Access Compliance Report Public Rights-of-Way (Curb Ramps)

Main Street: PETERS_AVE Cross Street: WILSON_ST Location: NW

ADA ID: RPRK210930115706 Ramp Type: Type 1 - Perpendicular Diagonal Initial Pass/Fail: Pass Overall Compliance: No Severity Score: 20

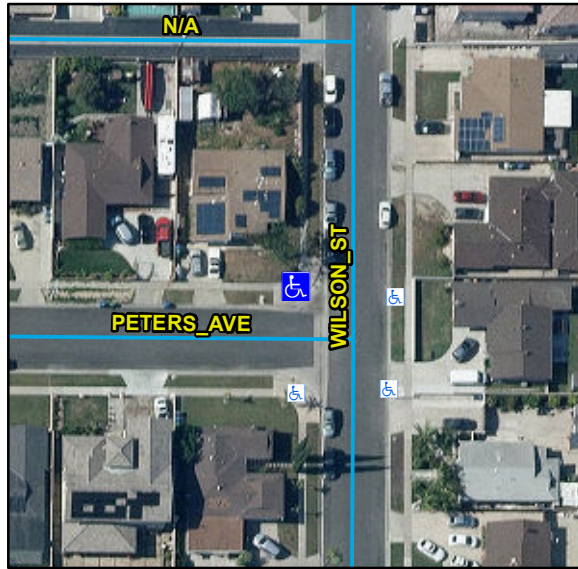
R304.2.1, R304.2.2-Perp, R304.3.2-Para, R304.5.3, R305, R302.7.2, STD 1115

Remove & Replace Curb Ramp With Two New Directional Ramps or Equivalent. Grind Gutter Lip.
